*Town of Somers*

**SOMERS PLANNING BOARD  
MEETING AGENDA  
AUGUST 13, 2014  
7:30 P.M.**

Heritage 202 Center  
Zone: NS  
Patio Pavers Application

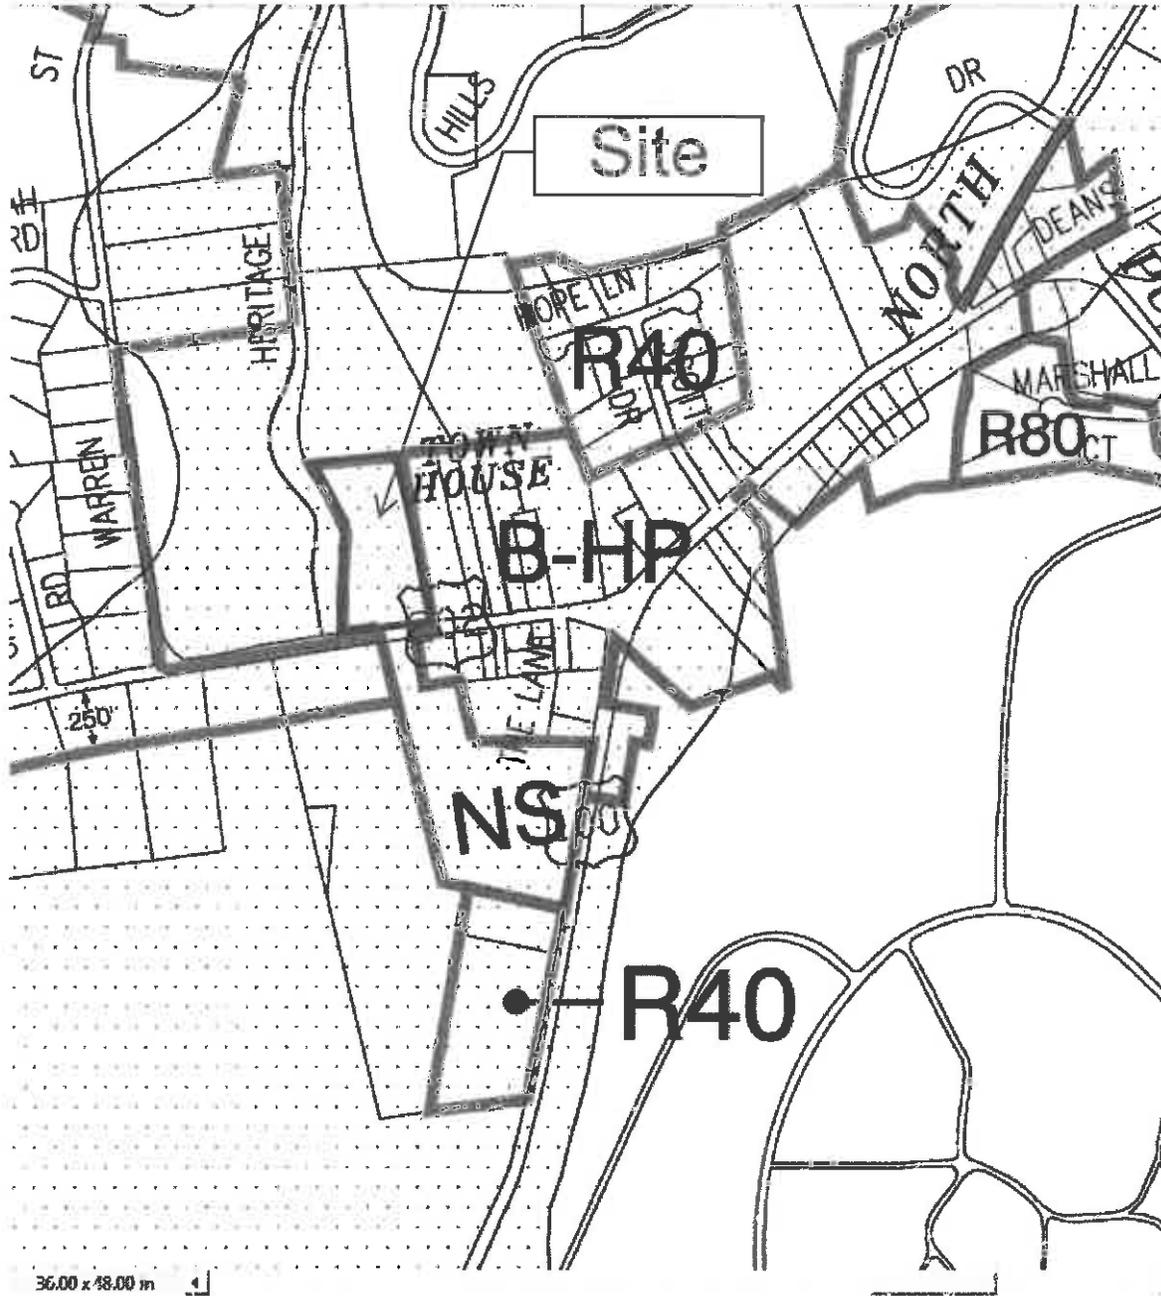
**B** - Remove existing shrubbery and install new nursery stock plantings

**A** - Remove existing shrubbery and install Hanover Permeable Paving Units on proper bedding - See details
